Summary of Comments on P:\Projects\1216-00\BIM\Revit
\Families\TITLEBLOCKS\EXTELL Proposal_atwalj.pdf

217 WEST 57TH STREET
NEW YORK, NY

DEPARTMENT OF BUILDINGS SUBMISSION
11 OCTOBER, 2012

VOLUME 2 OF 2 - ZONING

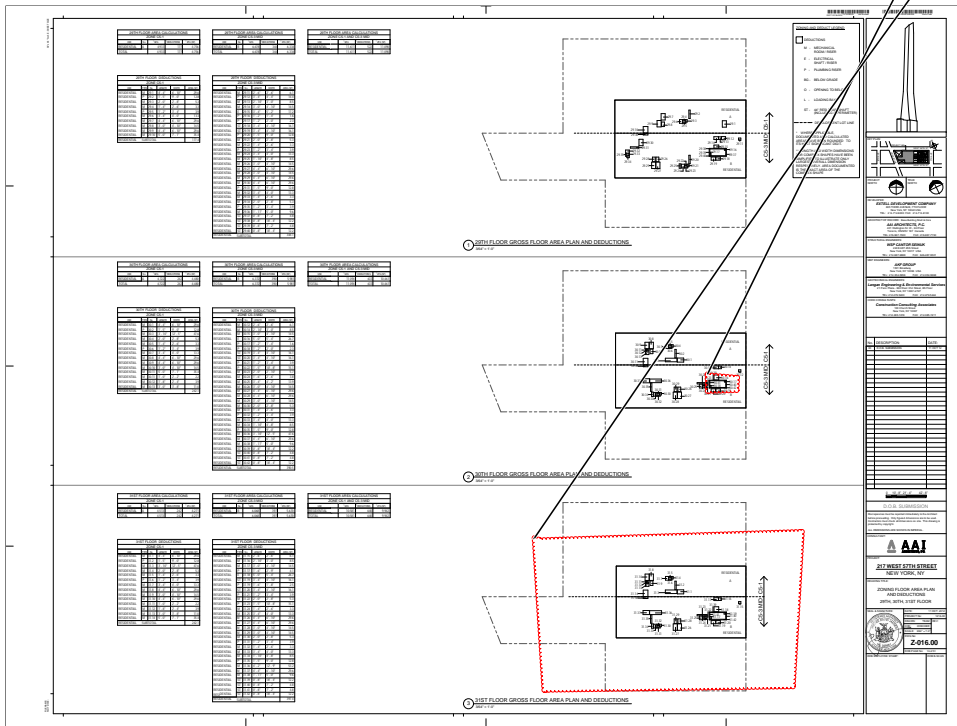
Please clarify deductions taken within stair inclosure. **TYP all floors**
8" for the stair perimeter, not sure what the additional 60+ sq. ft. is for per floor. ARCH/MH dwgs does not indicate any shaft enclosures within stair.

Mech. plan was not provided for this floor. 31st FL.

was not provided for this floor. 32nd FL.

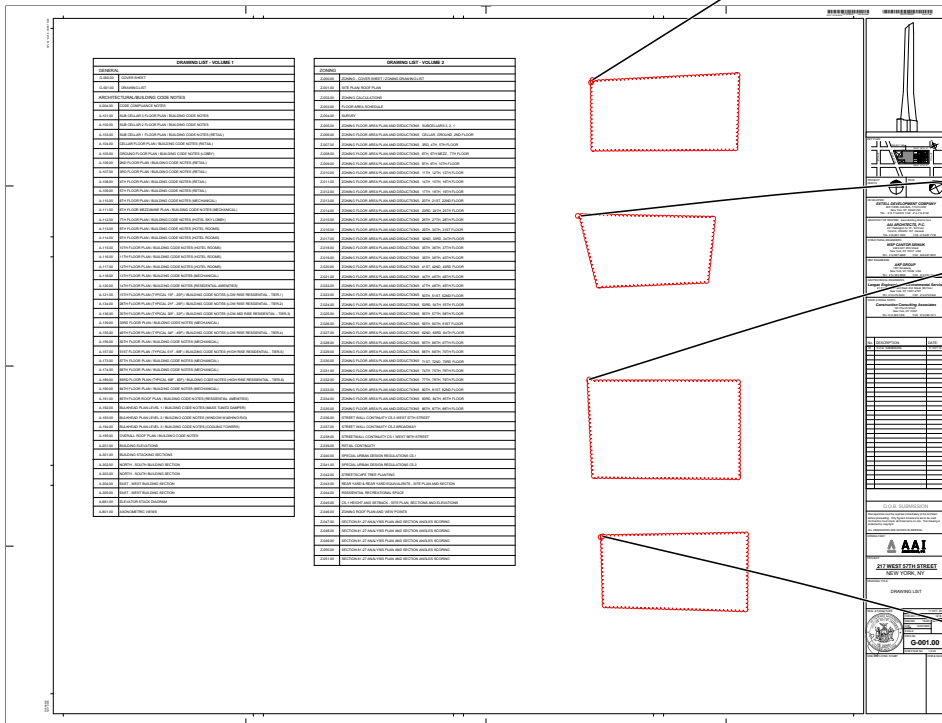
Supporting documentation: building wall sections fail to detail insulation as continuous and/or cavity insulation to match the location and R value in the energy analysis.

Supporting documentation: door, window and skylight schedules fail to provide columns for u values for each exterior door, window and skylight type. If door, window and skylight types are drawn instead, with specifications included next to the respective drawing, u and SHGC values must appear with the other performance specifications for clarity and ease of contractor take-offs.

Supporting documentation: heating and cooling systems, including controls, are not provided such that they match the systems, equipment and performance criteria in the energy analysis.

Supporting documentation: plans fail to include reflected ceiling plans or lighting layouts on floor plans with fixture types and quantities, lamp wattages and quantities, space areas, sensors and controls to match those in the energy analysis for each room in the building.

Supporting Documentation: Building wall sections fail to label insulation at the roof/ceiling, wall and/or at the foundation, slab-on grade, basement or cellar with R values matching those in the Energy Analysis.

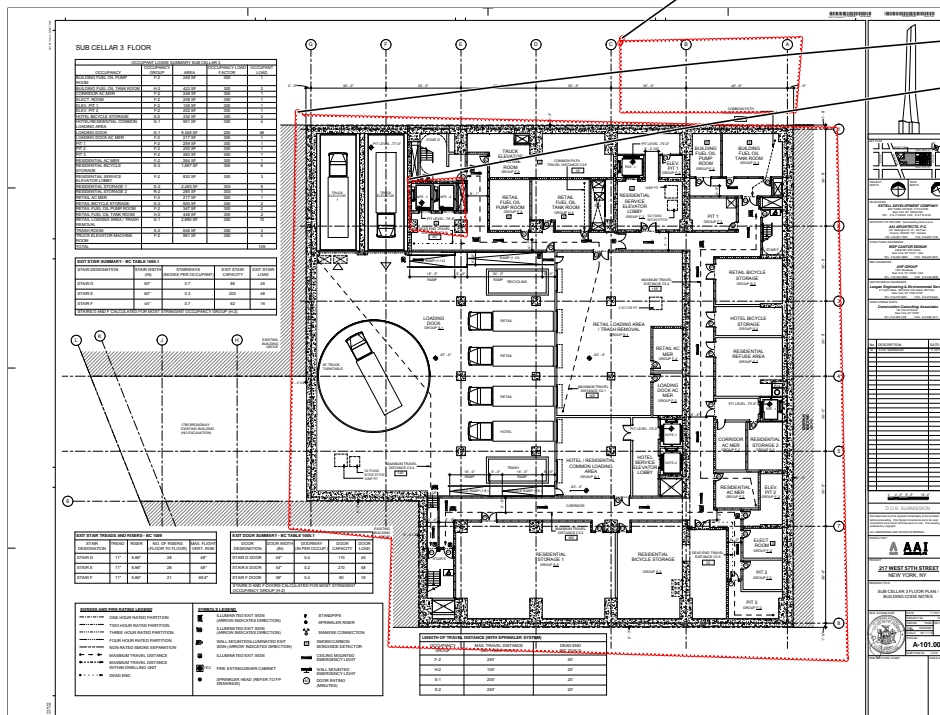
BC 903.2.10 Trash compactor is required for building which contains more than 12 units.

Indicate trash compactor size, dimensions, & location.

- indicate clearance around trash compactor
- Indicate sprinkler locations in the trash compactor room.
- indicate ventilation to fresh air at trash compactor room
- provide floor drain at trash compactor room
- Indicate a minimum, 3 hr fire rated enclosure (walls) at trash compactor room i, including 1 1/2hr FPSC rated door.
- indicate construction details and materials at trash compactor room
- Indicate sound transmission class (stc) ratings for all trash compactor walls and trash chute walls and disposal room walls.

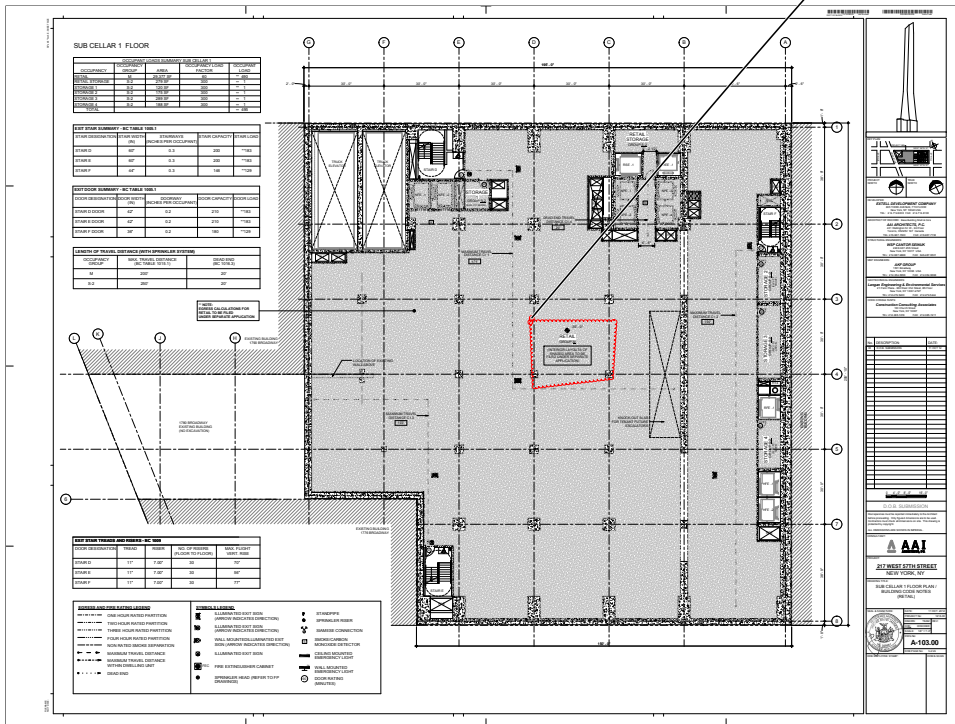
All nonresidential facilities to comply with BC 1109.

Show all grab-bars including vertical

Required clearance around the water closet to comply with ICC/ANSI 2003 604.3

TABLE 403.1 Provide table for plumbing fixtures to comply with table. 403.1. Provide calculations within each space, etc. and show layout to verify compliance to BC 1101.2; ICC/ANSI A117.1-2003

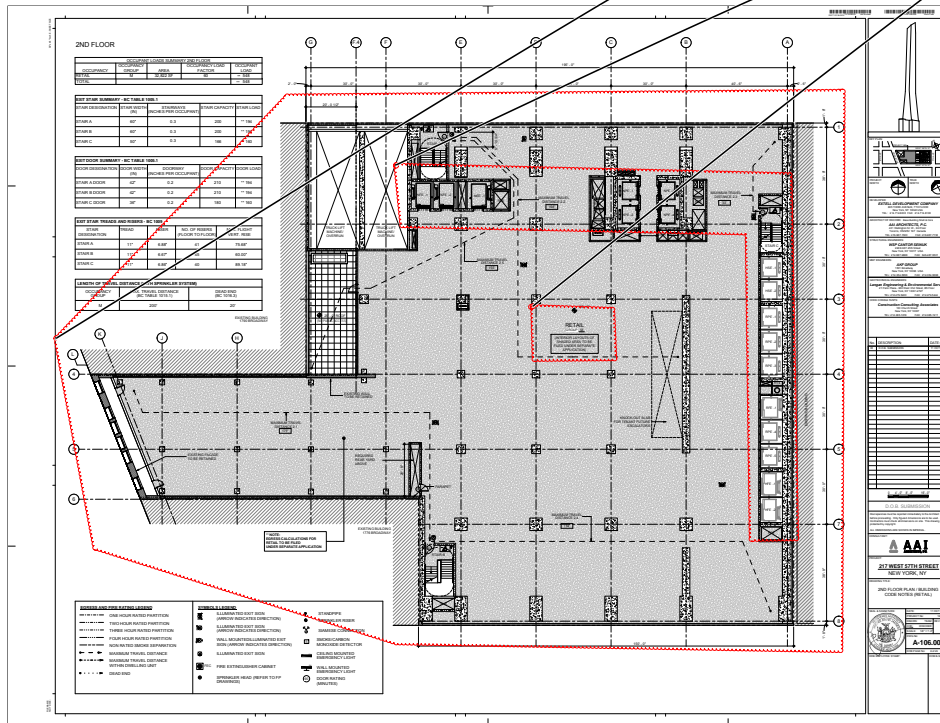
TABLE 403.1 Provide table for plumbing fixtures to comply with table. 403.1. Provide calculations within each space, etc. and show layout to verify compliance to BC 1101.2; ICC/ANSI A117.1-2003

All nonresidential facilities to comply with BC 1109.

Show all grab-bars including vertical

Required clearance around the water closet to comply with ICC/ANSI 2003 604.3

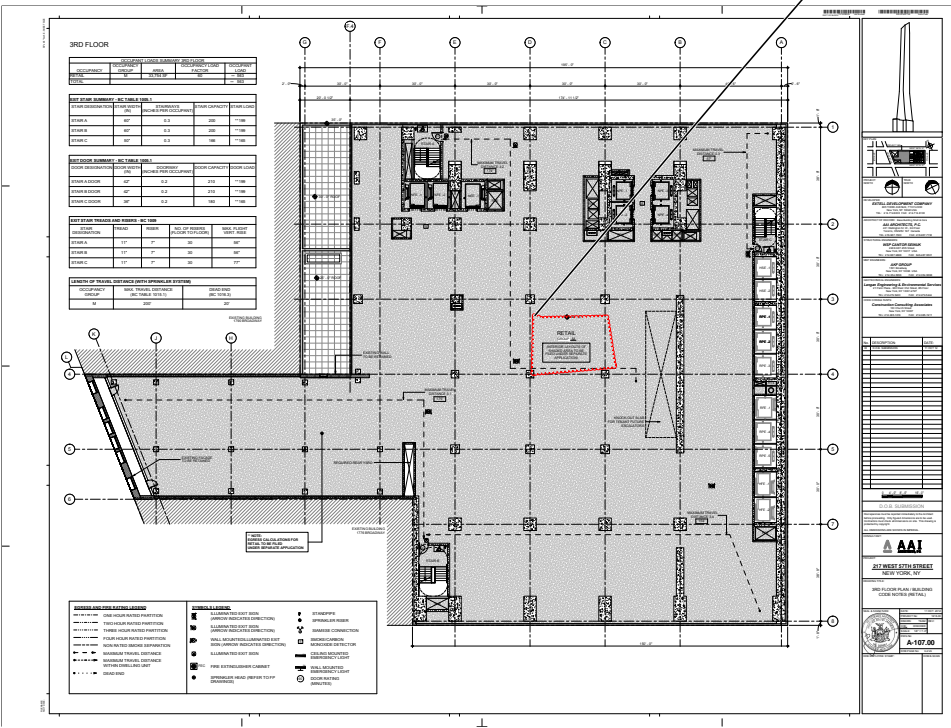
TABLE 403.1 Provide table for plumbing fixtures to comply with table. 403.1. Provide calculations within each space, etc. and show layout to verify compliance to BC 1101.2; ICC/ANSI A117.1-2003

All nonresidential facilities to comply with BC 1109.

Show all grab-bars including vertical

Required clearance around the water closet to comply with ICC/ANSI 2003 604.3

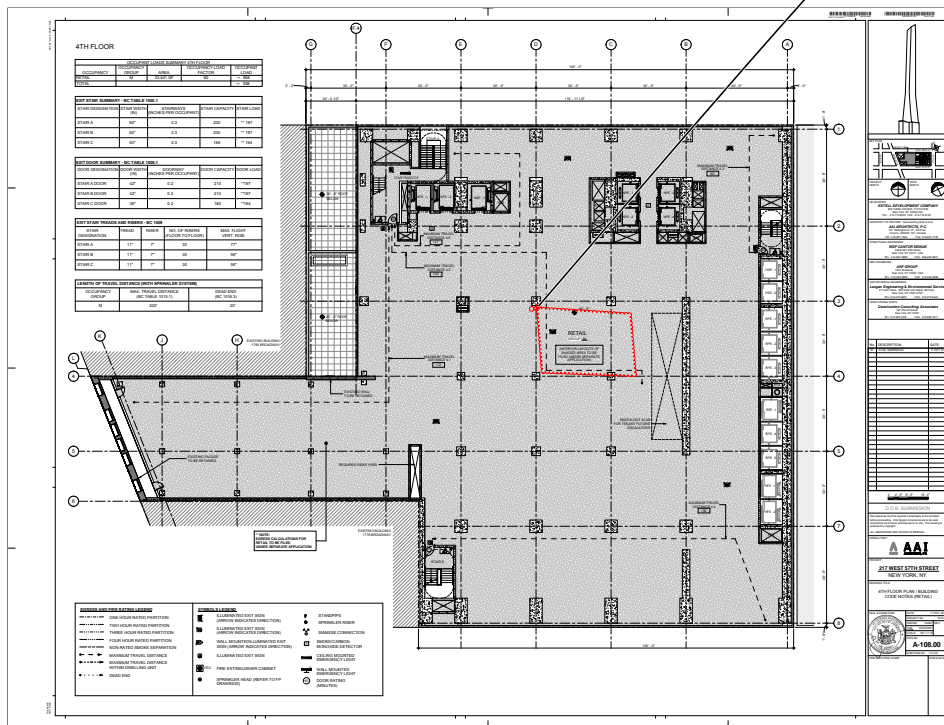
TABLE 403.1 Provide table for plumbing fixtures to comply with table 403.1. Provide calculations within each space, etc. and show layout to verify compliance to BC 1101.2; ICC/ANSI A117.1-2003

All nonresidential facilities to comply with BC 1109.

Show all grab-bars including vertical

Required clearance around the water closet to comply with ICC/ANSI 2003 604.3

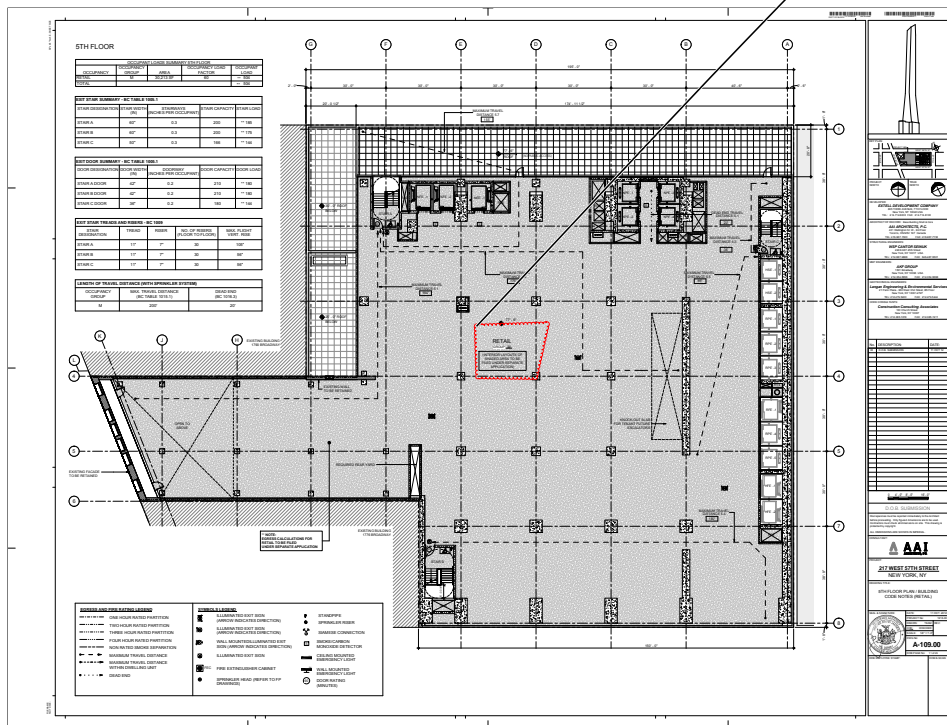
TABLE 403.1 Provide table for plumbing fixtures to comply with table. 403.1. Provide calculations within each space, etc. and show layout to verify compliance to BC 1101.2; ICC/ANSI A117.1-2003

All nonresidential facilities to comply with BC 1109.

Show all grab-bars including vertical

Required clearance around the water closet to comply with ICC/ANSI 2003 604.3

Provide exit lighting and directional signs (lighting) & (egress) as per BC 1006, BC 1011, BC 1026 (both EG and Construction plans)

BC 903.2.12.2 Commercial cooking operations. An automatic sprinkler system shall not be installed in a commercial kitchen exhaust hood and duct system. Fire extinguishing systems shall be installed in commercial cooking systems in accordance with Section 904.11.

BC 904.2.1 Hood system suppression. Each required commercial kitchen exhaust hood and duct system required by the *New York City Fire Code* or the *New York City Mechanical Code* to have a Type I hood shall be protected with an approved automatic fire-extinguishing system installed in accordance with this code.

Kitchen shall also comply with MC 506, 507, and 508; PC 802.1.7 and 1003.3.1. Please verify on MH/PL plans.

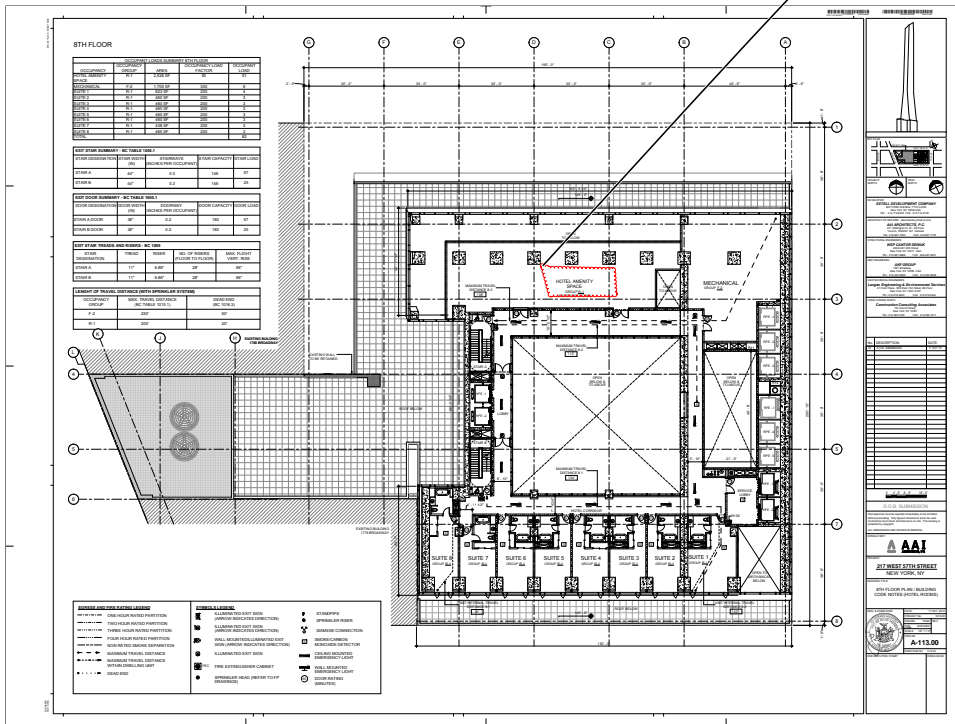
TABLE 403.1 Provide table for plumbing fixtures to comply with table. 403.1. Provide calculations within each space, etc. and show layout to verify compliance to BC 1101.2; ICC/ANSI A117.1-2003

All nonresidential facilities to comply with BC 1109.

Show all grab-bars including vertical

Required clearance around the water closet to comply with ICC/ANSI 2003 604.3

Provide exit lighting and directional signs (lighting) & (egress) as per BC 1006, BC 1011, BC 1026 (both EG and Construction plans)

The common path of egress travel shall not exceed 125 feet as per BC 1013.3. The maximum length of exit access travel, measured from the most remote point within a story/space to the entrance to an exit along the natural and unobstructed path of egress travel, shall not exceed the distances given in BC Table 1015.1.

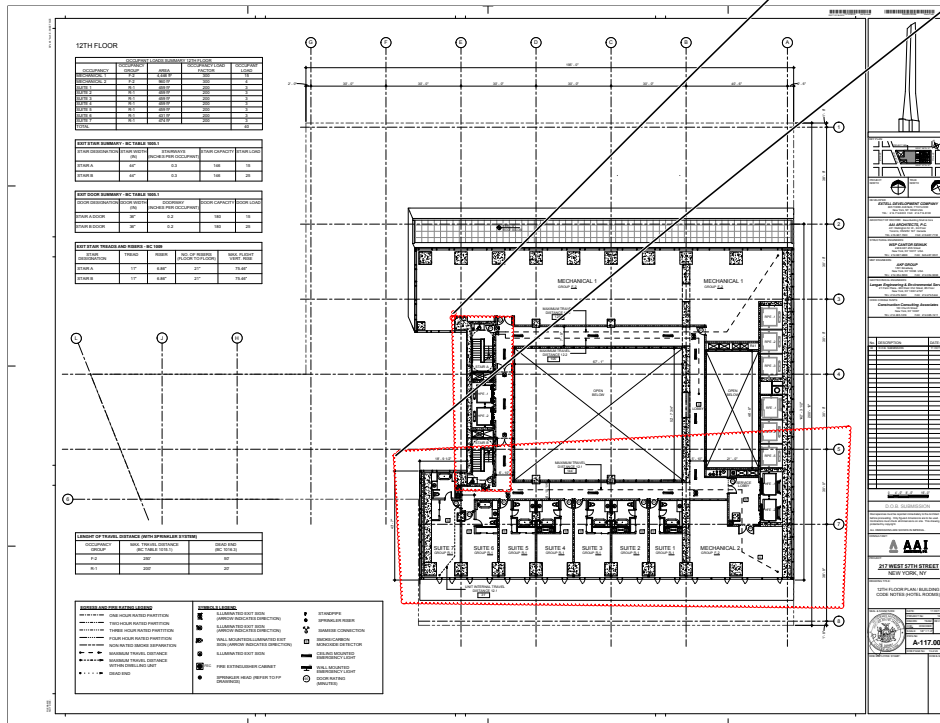
Group R-1 occupancies shall be provided with accessible features in accordance with Sections 1107.6.1.1 through 1107.6.1.3.

Show all grab-bars including vertical as per P102.8.3.1, (TYP)

Provide note within each accessible unit: unit or sleeping unit shall comply with the 2008 code and Chapter 1 through Chapter 10 of ICC A117.1.

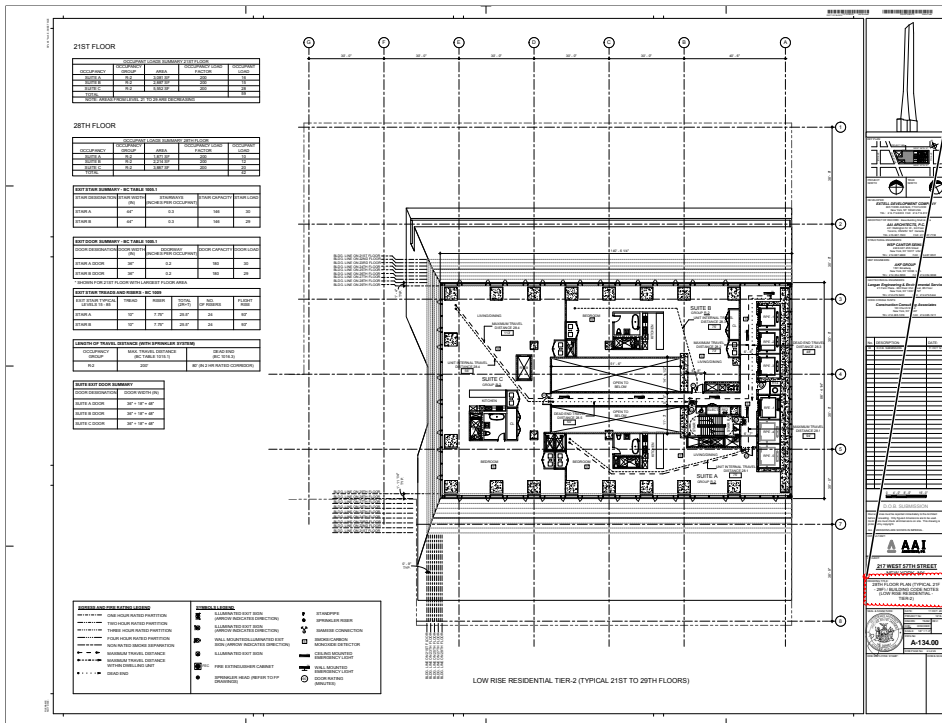
Author: dtitus Subject: Polygon Date: 1/7/2013 9:31:18 AM
The common path of egress travel shall not exceed 125 feet as per BC 1013.3. The maximum length of exit access travel, measured from the most remote point within a story/space to the entrance to an exit along the natural and unobstructed path of egress travel, shall not exceed the distances given in BC Table 1015.1.

Author: dtitus Subject: Polygon Date: 1/7/2013 9:30:14 AM
BC 908.7.1.2 Provide notes to indicate compliance for carbon monoxide detectors.
Indicate location of smoke/ carbon monoxide detectors. (TYP.)

Author: dtitus Subject: Polygon Date: 1/4/2013 10:06:27 AM
Provide refuse chute details: [2 hr fr walls & roof] and compliance with BC 1213.3 and BC 707.13
Refuse storage room to comply with BC 1213.1
Provide proper enclosure and details
Provide UL # for system or fire hopper doors
Compliance with BC 1101.2;

Author: dtitus Subject: Polygon Date: 1/4/2013 10:41:39 AM
Provide note describing stairway door operation and stairway communications system as per BC 403.12
Provide note describing smoke proof exit enclosures for compliance with BC 403.13.
Provide note describing impact-resistant stairs enclosures as per BC 403.15
Provide exit lighting and directional signs (lighting) & (egress) as per BC 1006, BC 1011, BC 1026 (both EG and Construction plans)

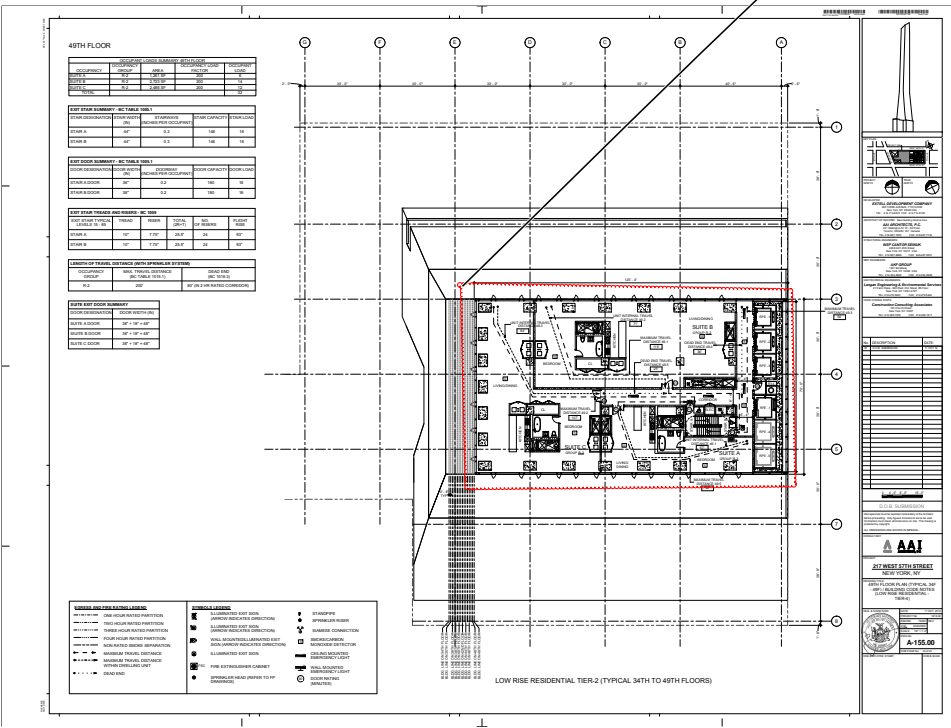
BC 1101.1, 1101.2, and
ICC/ANSI A117.1-2003 Verify compliance with accessibility as per BC 1101
Primary access- 1105
Doors & maneuvering clearances-1107.2.1
Residential bathrooms – 1107/ Appendix P
Residential kitchens – 1107.
Show all grab-bars including vertical as per P102.8.3.1,
Walk-in closets
Access to W/D within units
TYP. all R-2 floors

Provide fire protection of openings in exterior walls (BC 704.8, BC 705.8, BC 715.4).

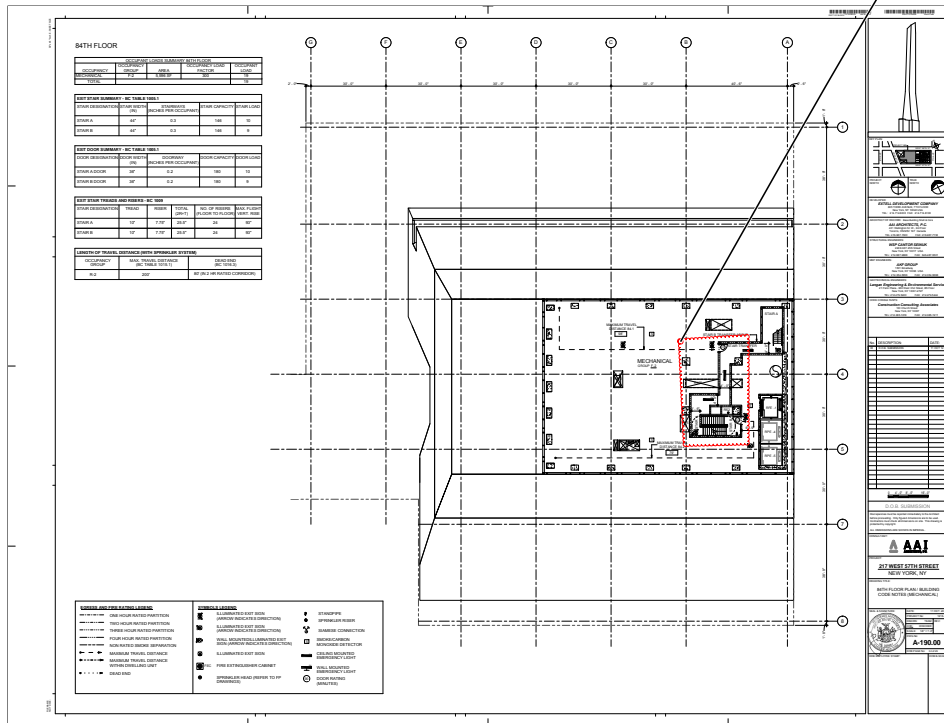
Author: dtitus Subject: Polygon Date: 1/4/2013 10:08:37 AM
A-occupancy

BC 403.11.1 Emergency power systems for assembly occupancy

1. Exit signs and means of egress illumination required by chapter 10.2.
3. emergency voice communications systems; and
4. Electrically powered fire pumps, unless electrical power to the motor is taken ahead of the main from the street side of the service switch.

Author: dtitus Subject: Polygon Date: 1/2/2013 11:59:00 AM
All interior stairs must lead to the roof as per BC 1009.12
